ADDENDUM NO. 5

City of Springfield CITY COMPLEX

Mott MacDonald Project No.: 502100062

September 12, 2024

SHEET NUMBER:
C1.3

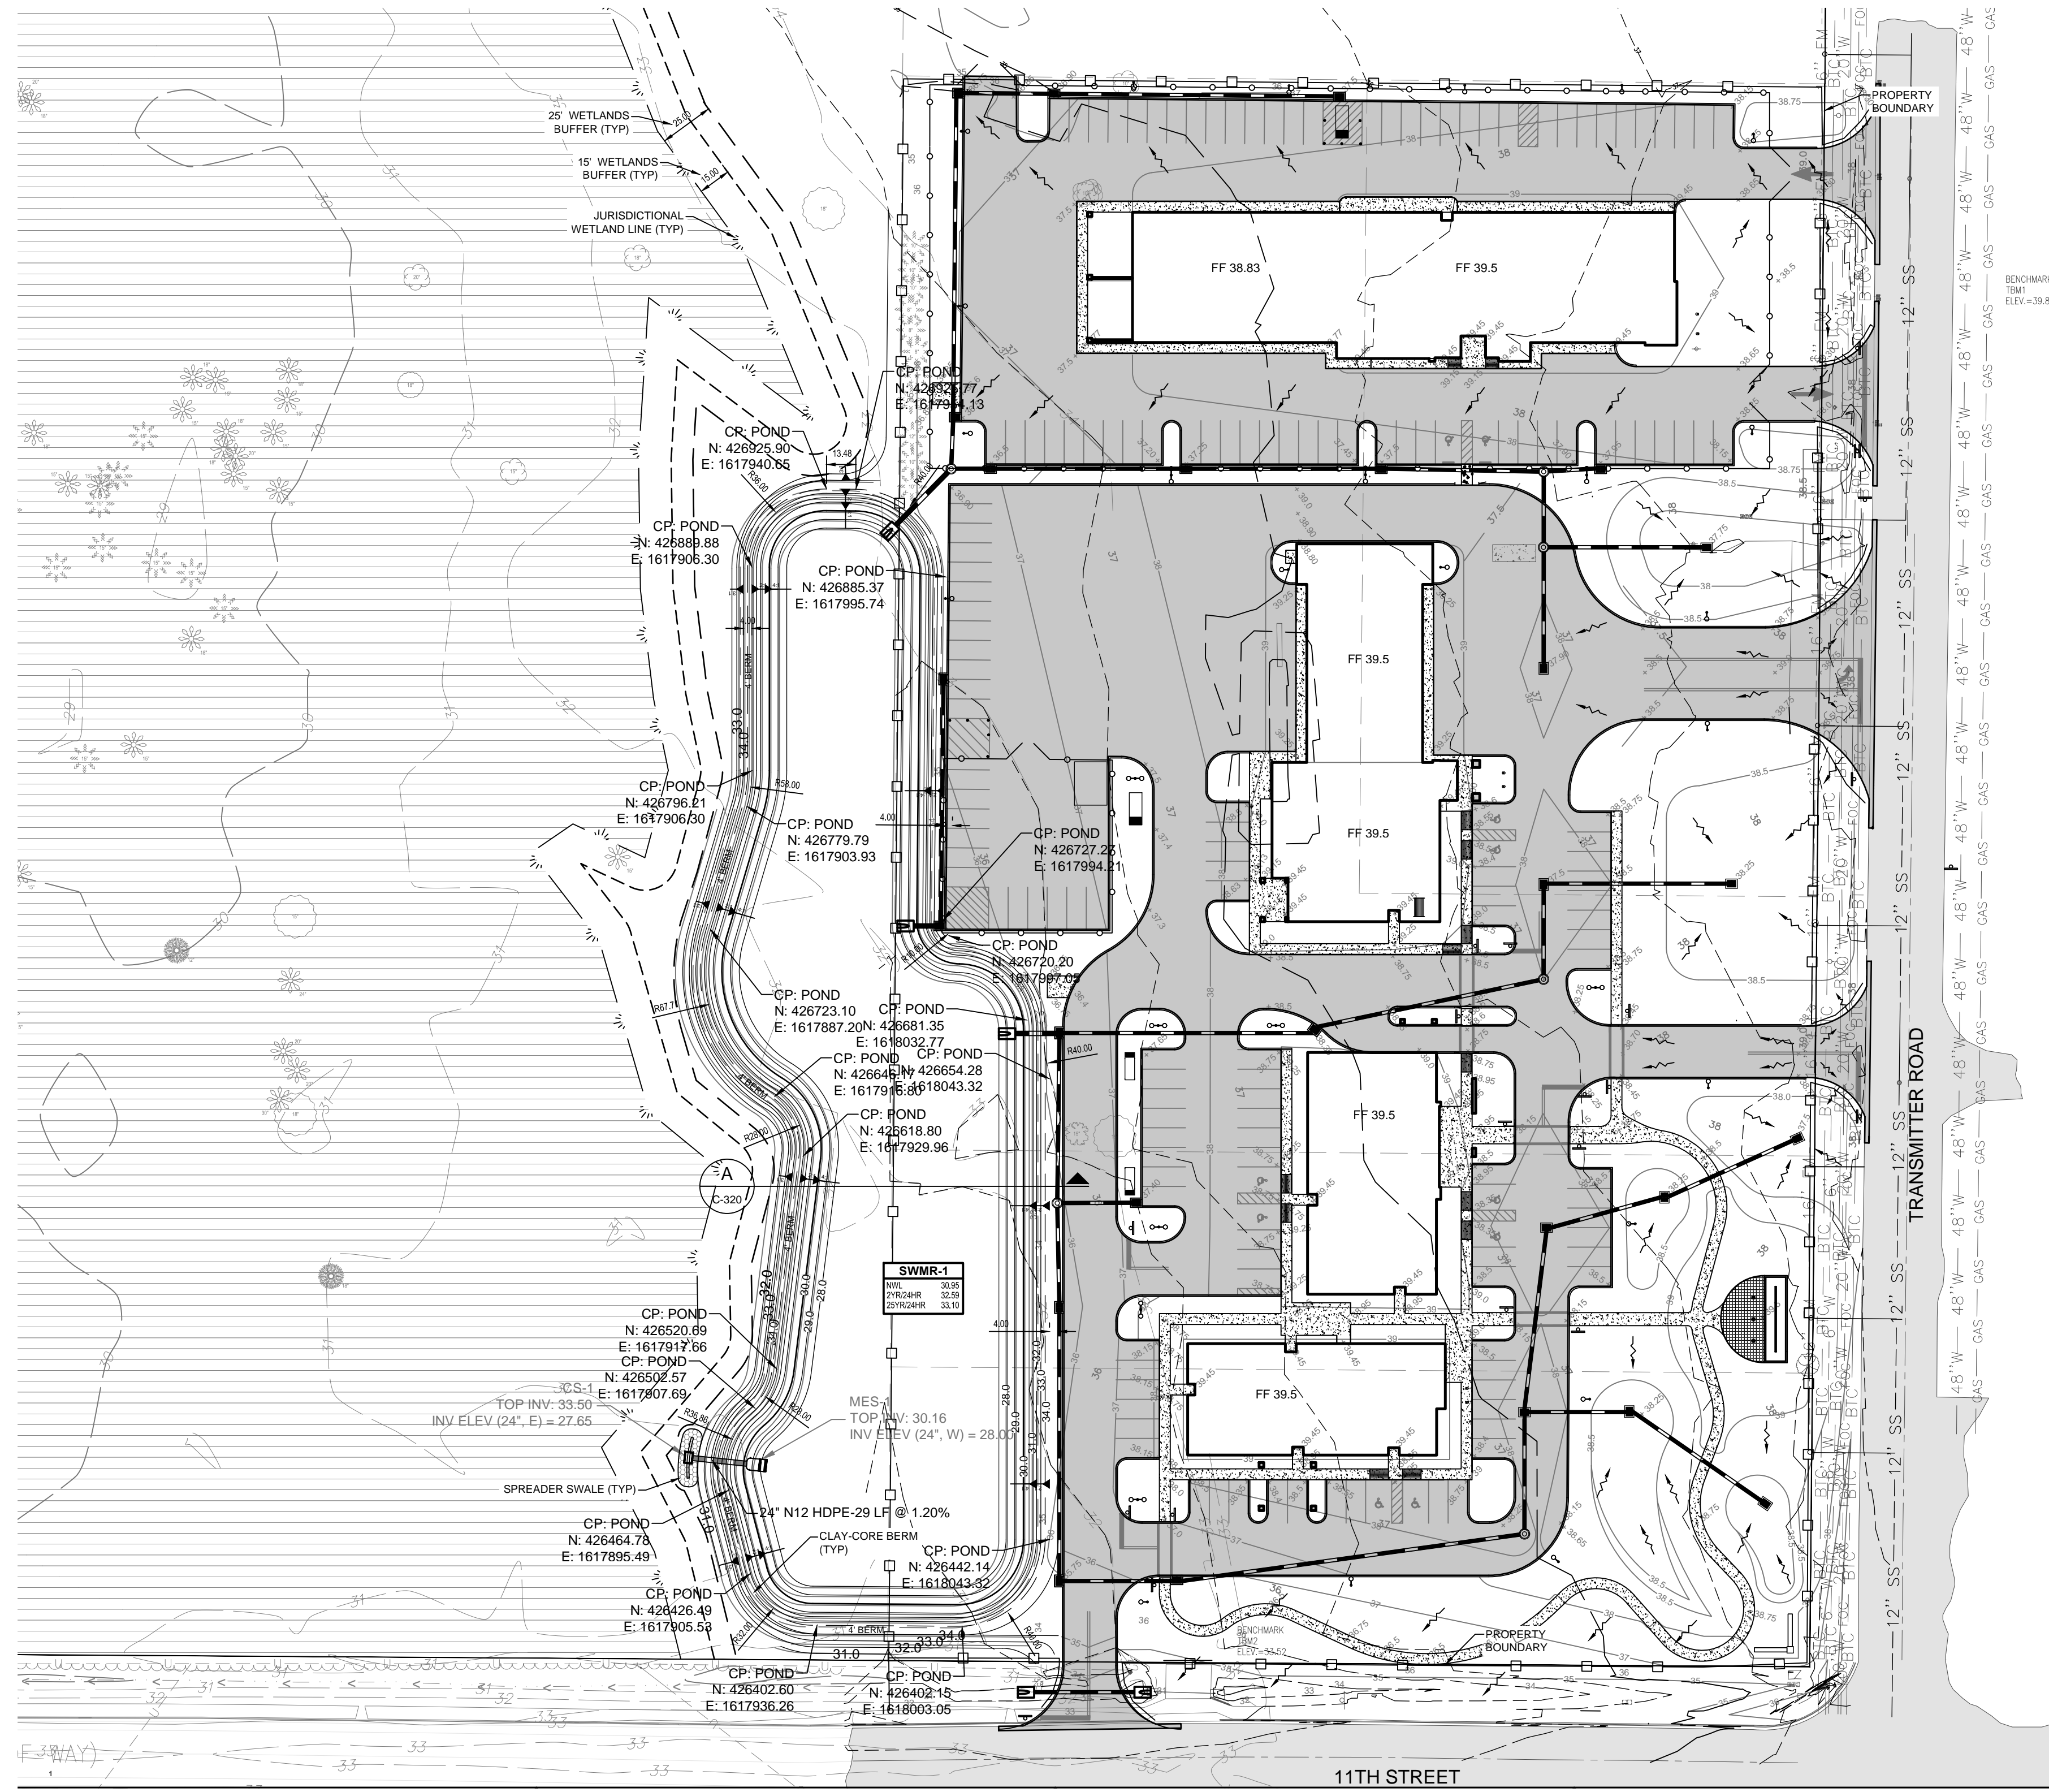
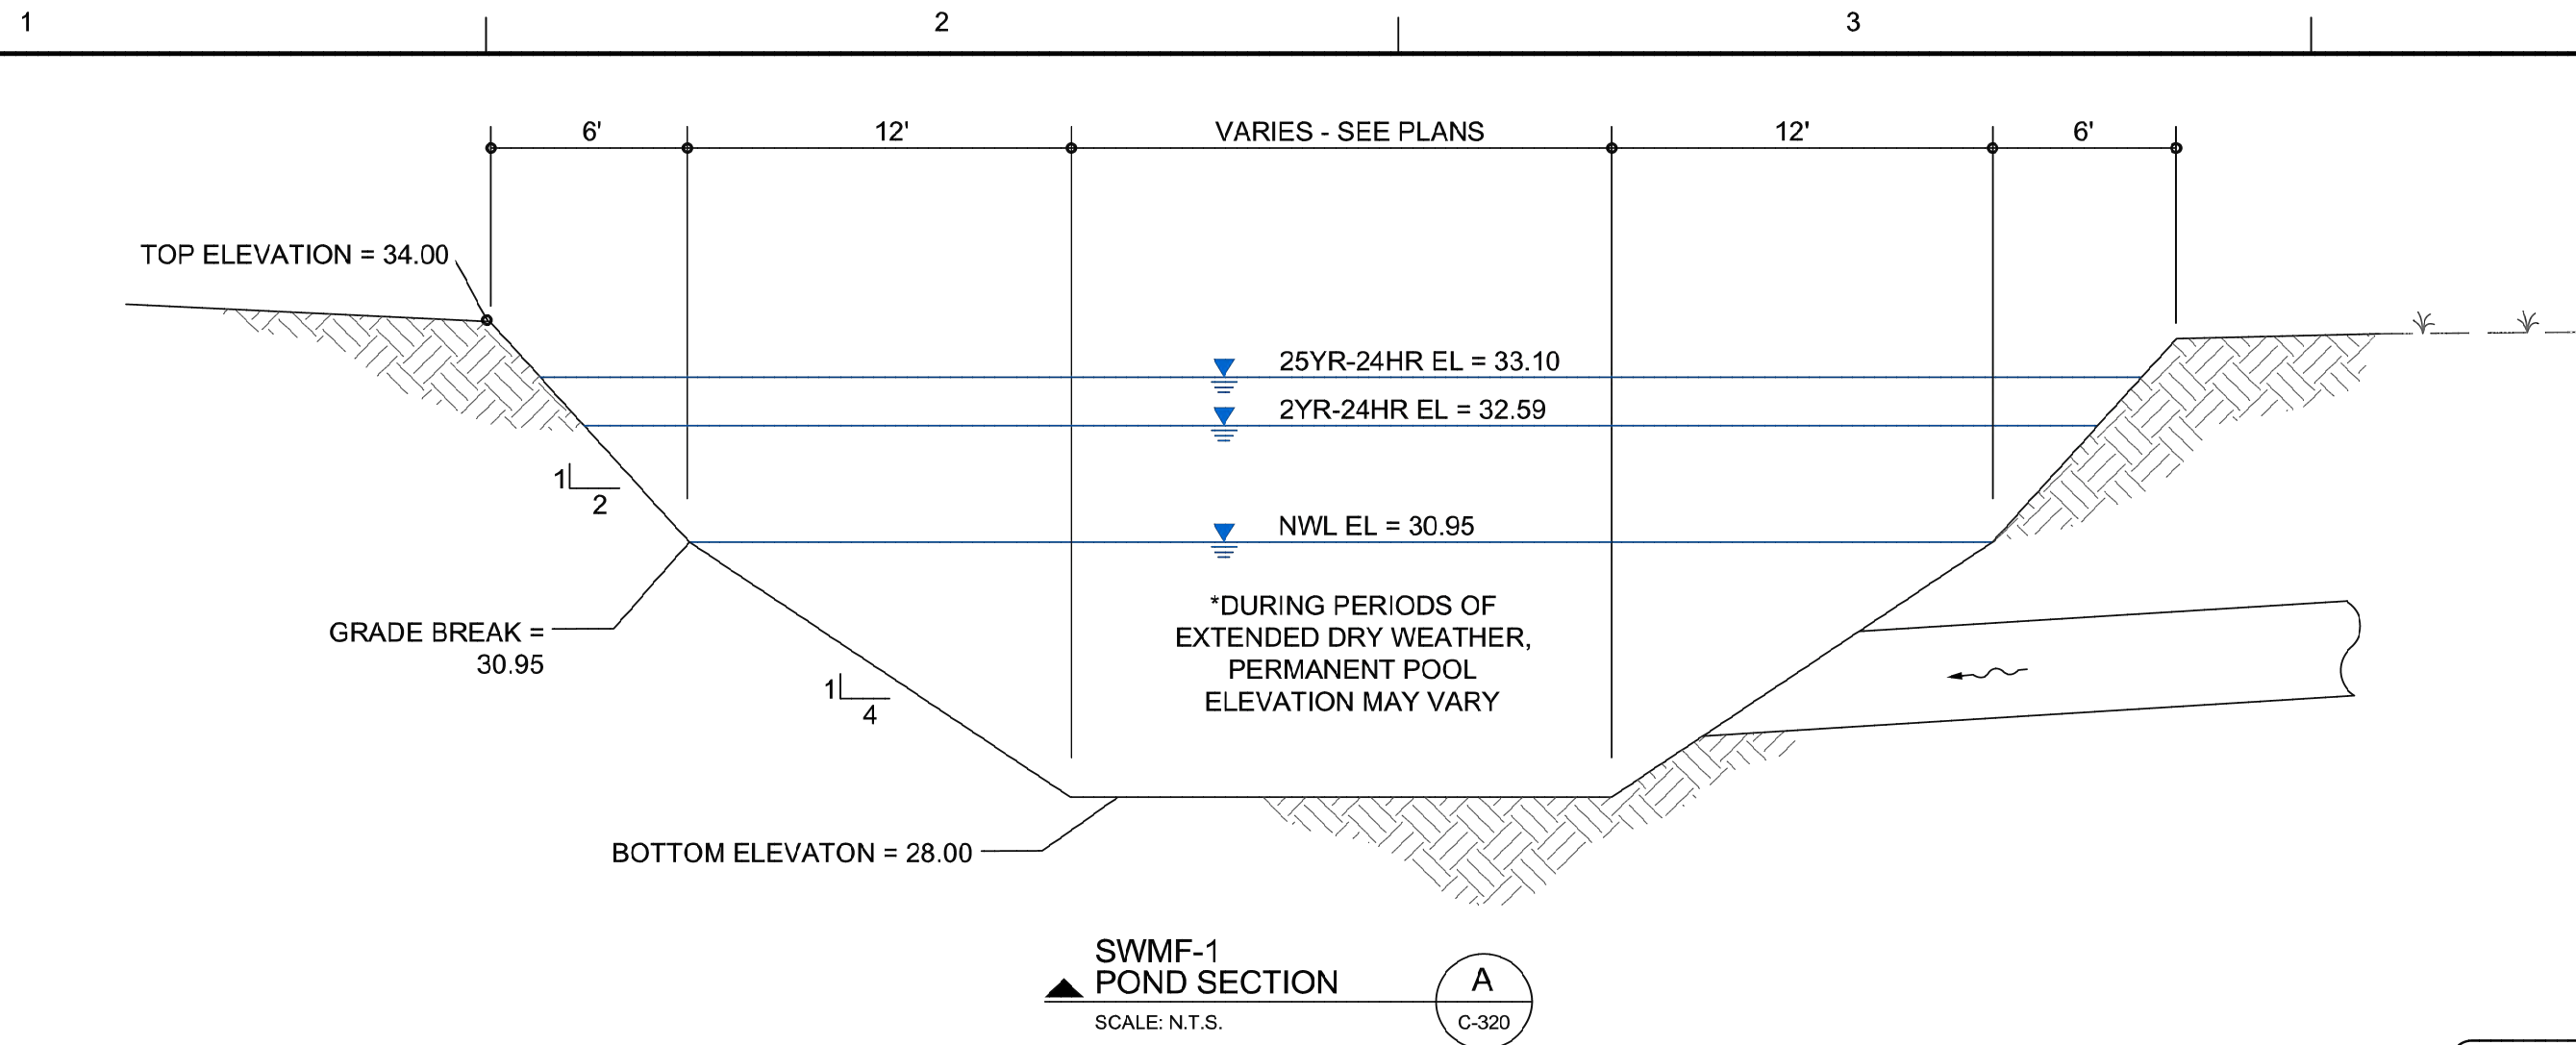
- 1. Sheet C1.3 has been revised by the addition of earthwork volumes and related notes and is attached to this Addendum No. 5 as C1.3 Rev.
- 2. New Plan Sheet C1.4 "Grading Details" which provides details of the stormwater pond is hereby added and is attached to this Addendum No. 5.

98. QUESTION: On sheet C 1.3/C-301 it states Clay-Core berm on the lower part of the pond, can we get a detail and limits of the Clay- Core berm? Also on the same sheet it's showing a Spreader swale at the outfall discharge, can a detail be provided for the spreader swale? RESPONSE: A revised Sheet 1.3 Rev. and a new Sheet 1.4 have been added and are attached to Addendum #5 to which these questions are also attached.

NOTE:
 THE EARTHWORK VOLUMES ARE REPRESENTATIVE OF EXISTING
 IN PLACE VOLUMES OF EARTH, AND PROPOSED IN PLACE
 VOLUMES OF EARTH. NO ADJUSTMENTS HAVE BEEN MADE FOR
 SHRINKAGE OR LOSS, AND THE CONTRACTOR SHALL REVIEW
 GEOTECH INFORMATION CONTAINED IN THE PROJECT
 SPECIFICATIONS FOR DETERMINATION HOW MUCH OF THE IN
 PLACE MATERIAL MIGHT BE USABLE TO OFFSET THE NEEDED FILL
 QUANTITY.

EARTHWORK VOLUMES (UNFACTORED)

CUT = 6551 C.Y.
 FILL = 30484 C.Y.
 NET FILL = 23933 C.Y.
